Addendum

October 14, 2024 Questions/Answers

RFP 24-036 Commercial Grade Kitchen Renovation

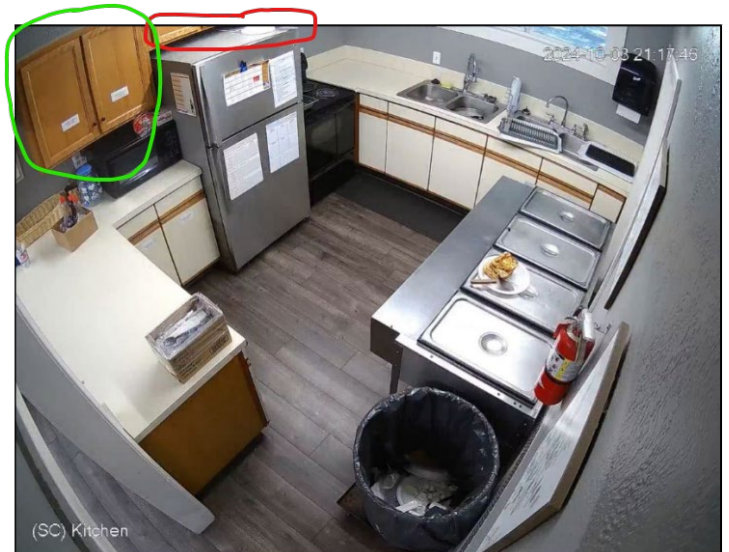
Q5. What are the changes to the cabinet/cupboard quantity?

A5. The bid should include all cabinets, drawers, and one set of cupboards. We are eliminating the cupboards above the stove and refrigerator.

- Eliminate the cupboards circled in red.
- Replace the cupboards circled in green.
